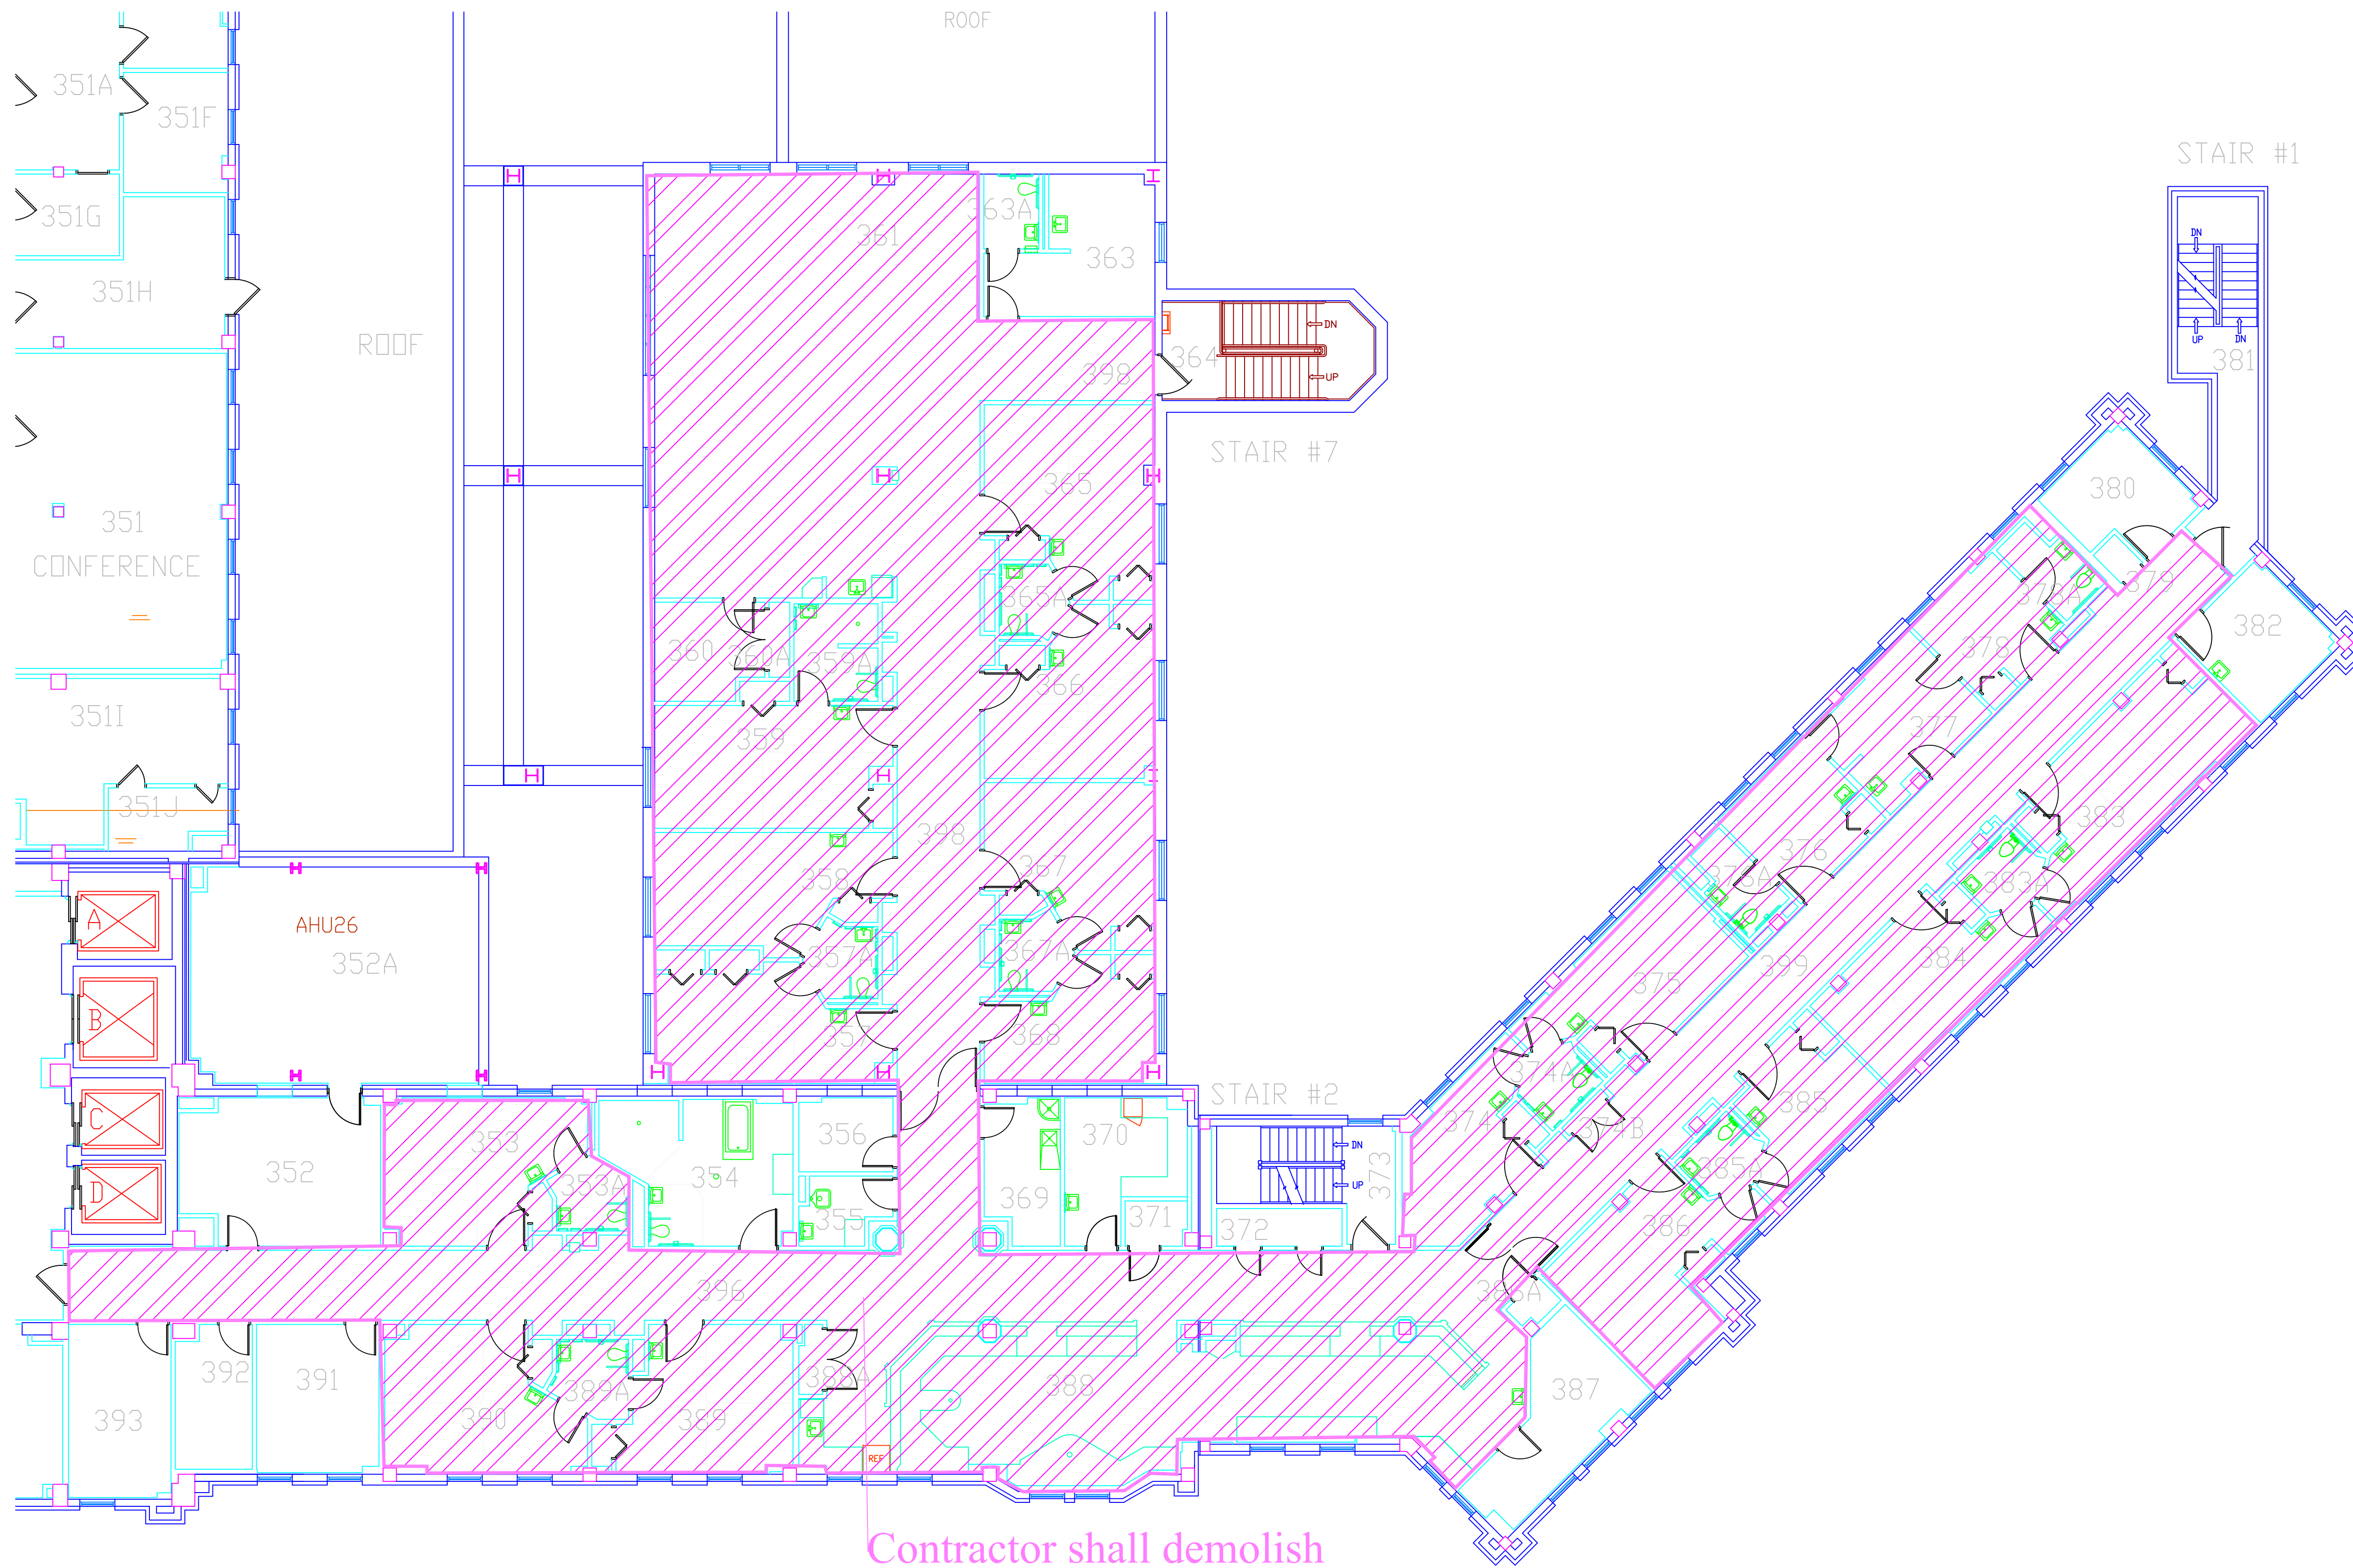
All alcove built-in cabinetry circled in red indicated in plan shall be demolished and walls repaired and finished according to finish schedule.

Contractor shall demolish and replace ceiling grid and tile in all areas hatched in pink on plan. See SOW and finish schedule for ceiling grid and tile specifications.

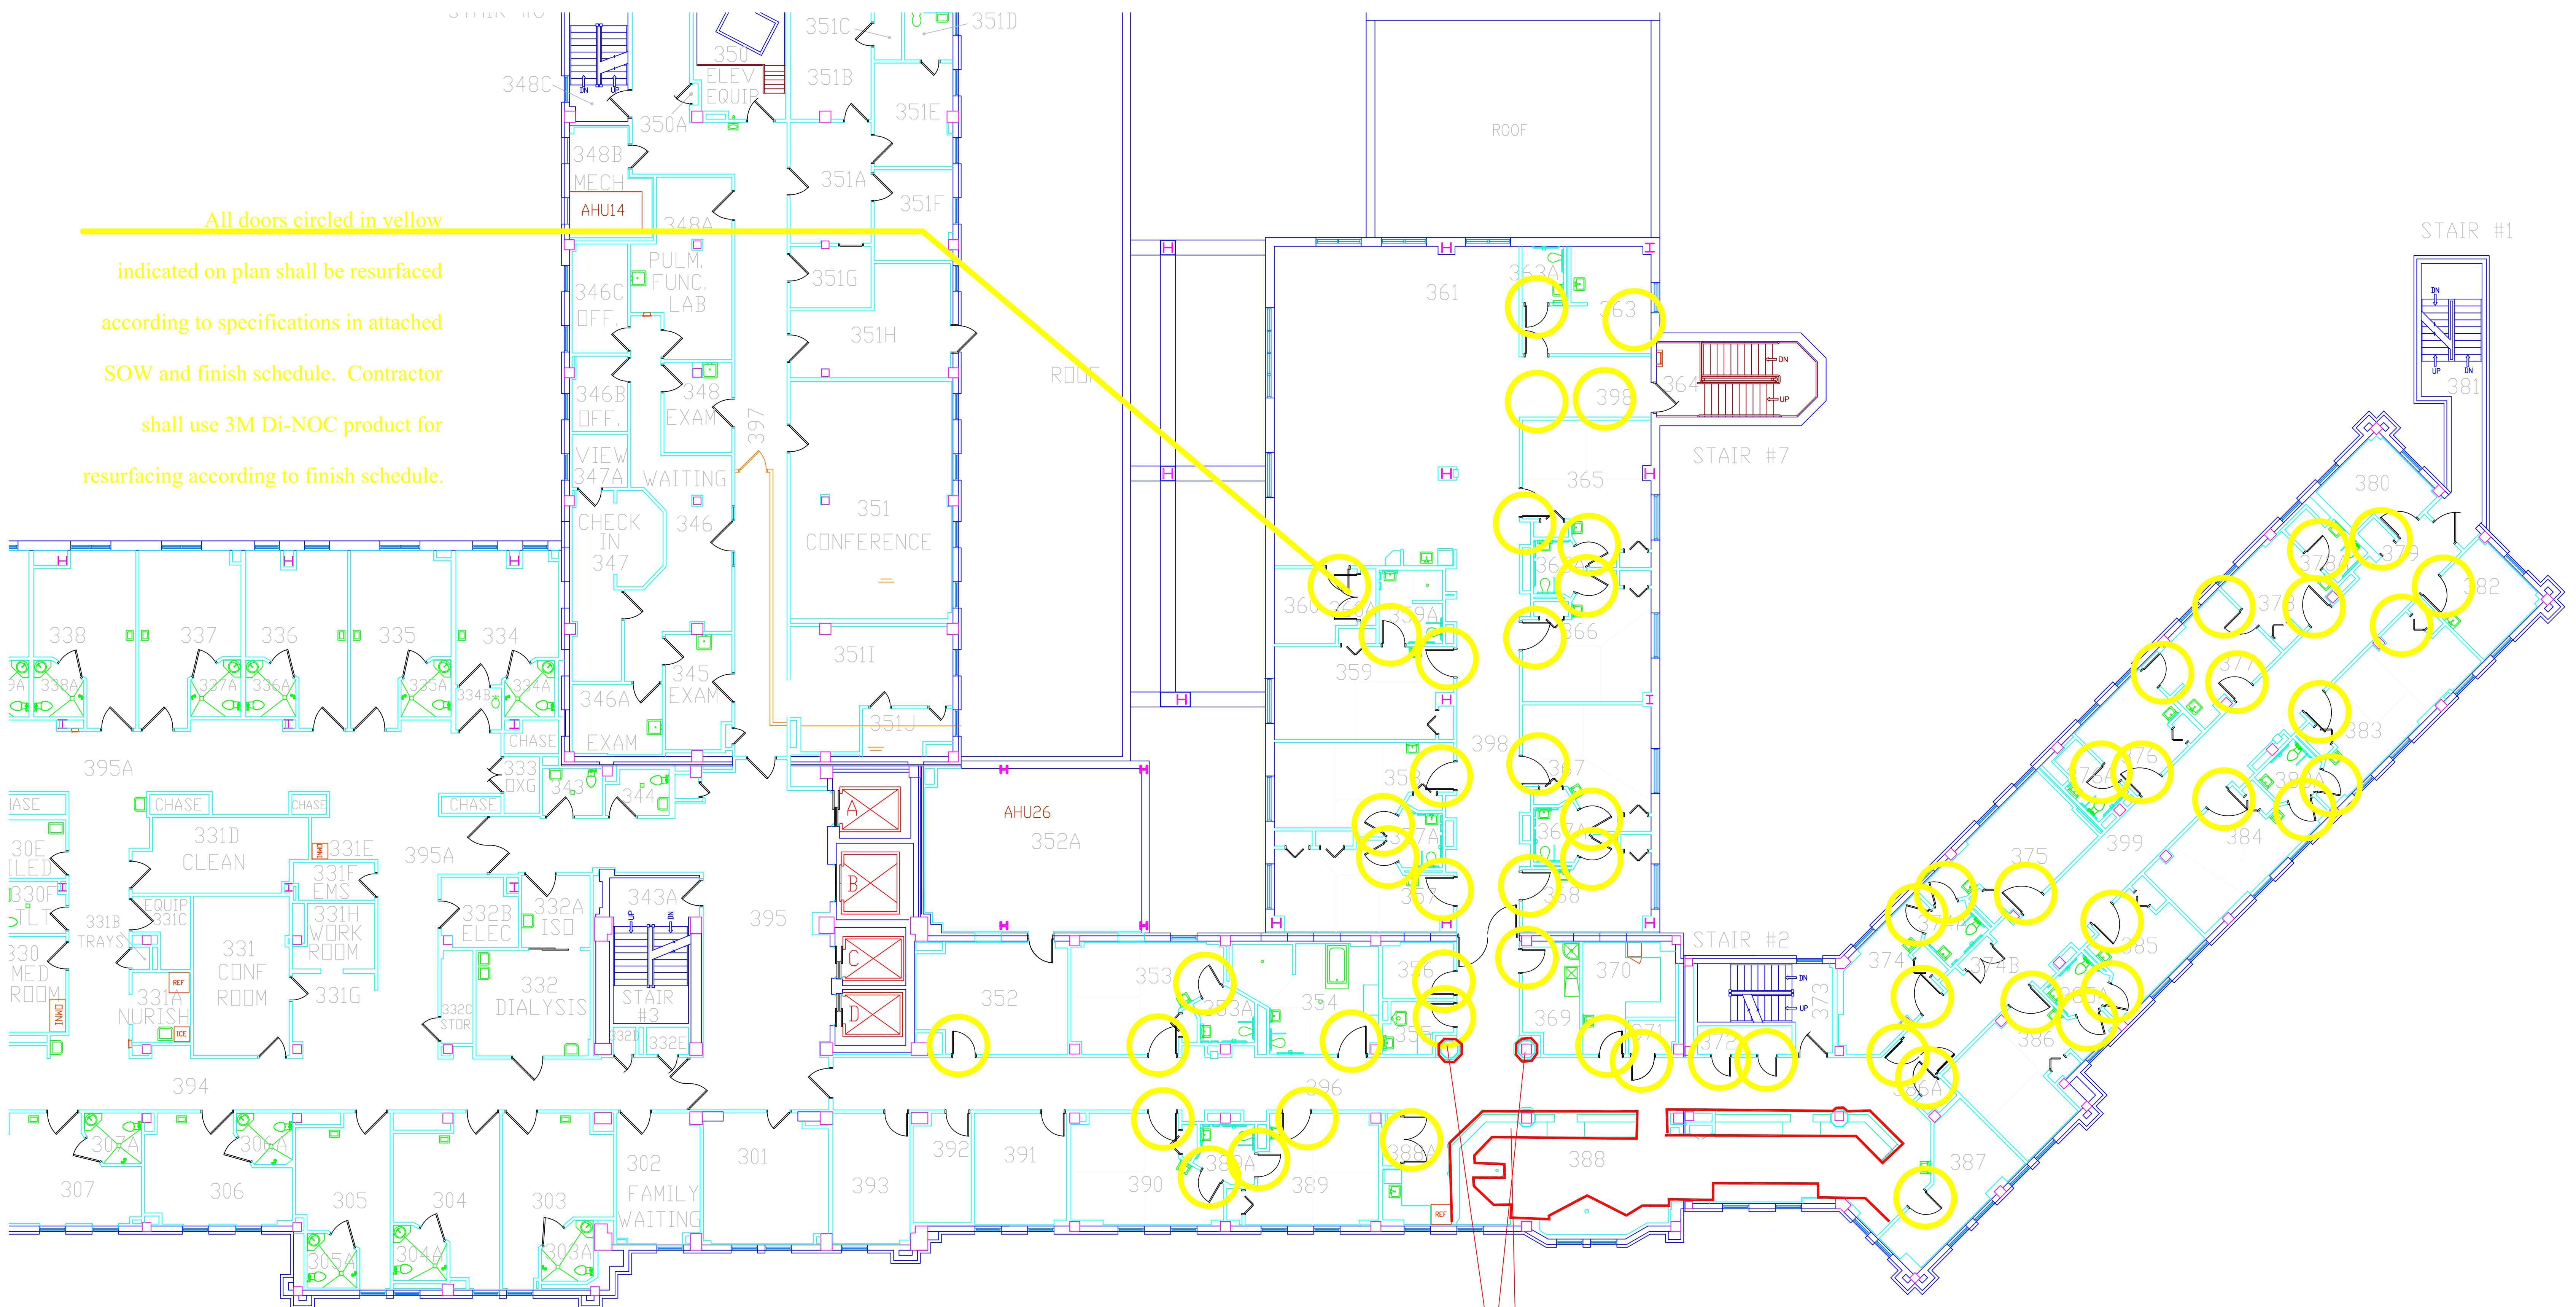
All doors circled in yellow indicated on plan shall be resurfaced according to specifications in attached SOW and finish schedule. Contractor shall use 3M Di-NOC product for resurfacing according to finish schedule.

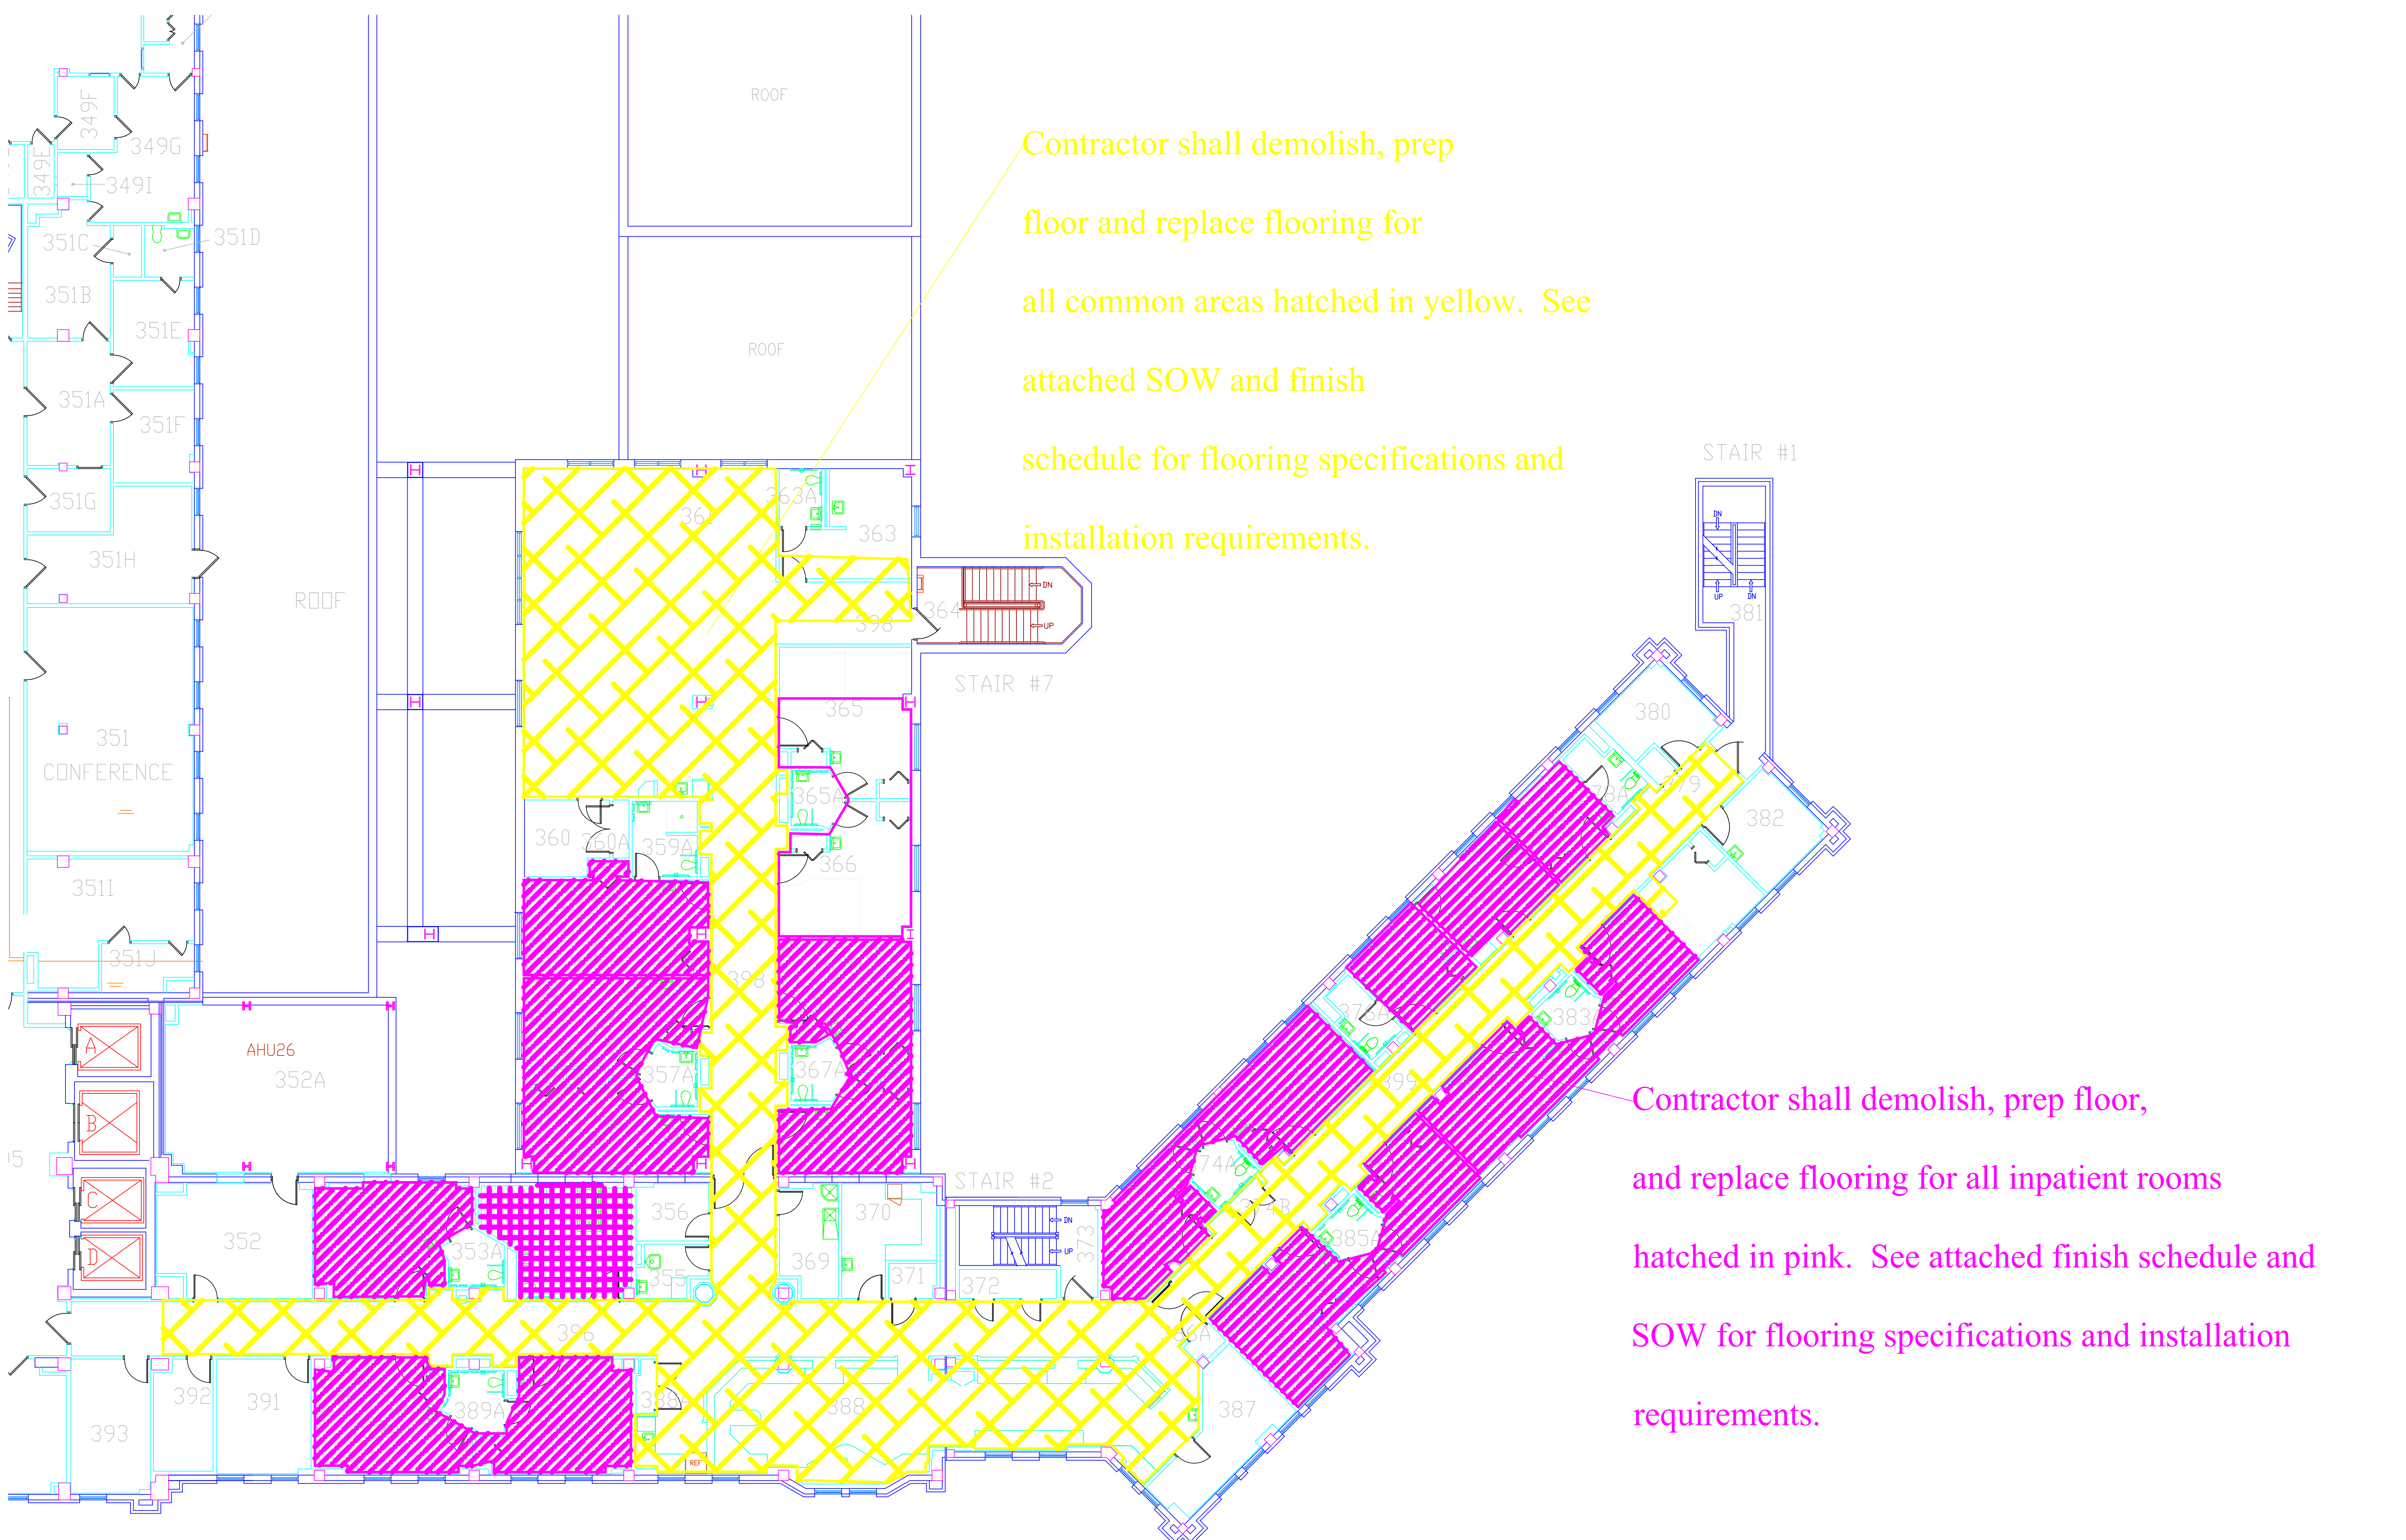
All surfaces indicated on plan in red shall be resurfaced with 3M Di-Noc product. See attached finish schedule for finish specifications.

Contractor shall demolish, prep floor and replace flooring for all common areas hatched in yellow. See attached SOW and finish schedule for flooring specifications and installation requirements.
